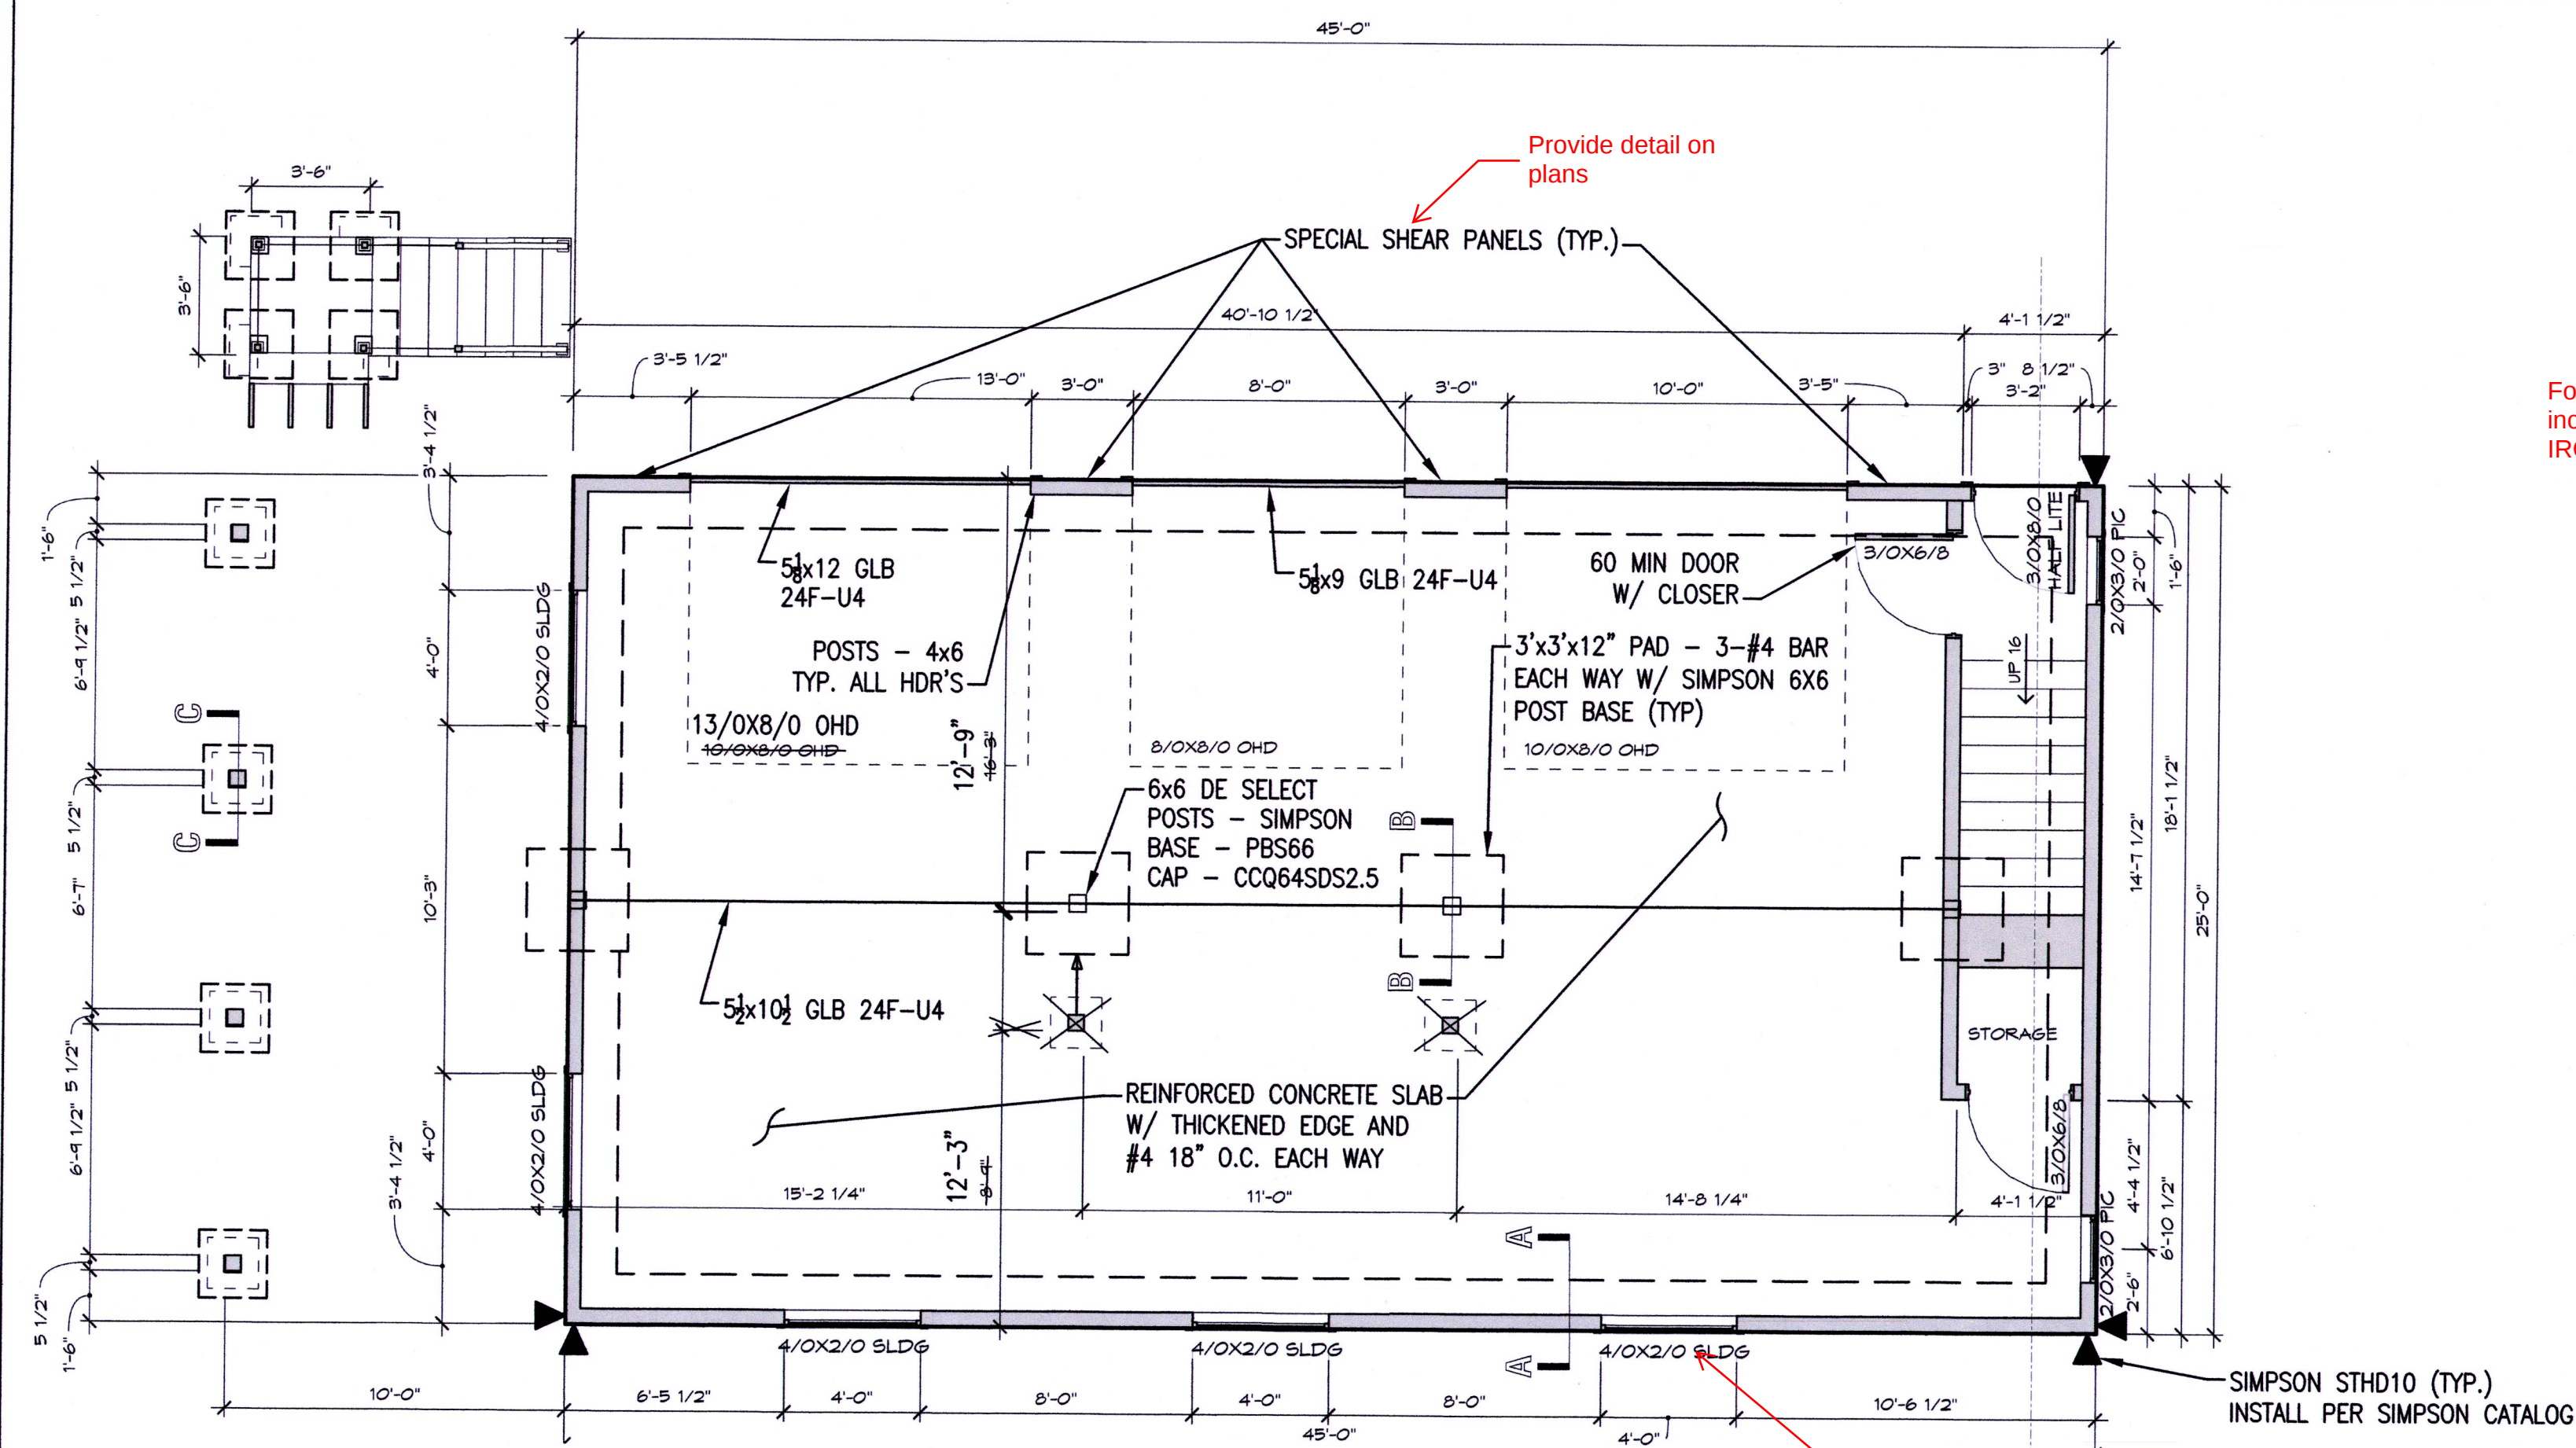
- All beams and headers shall be labeled on plans.
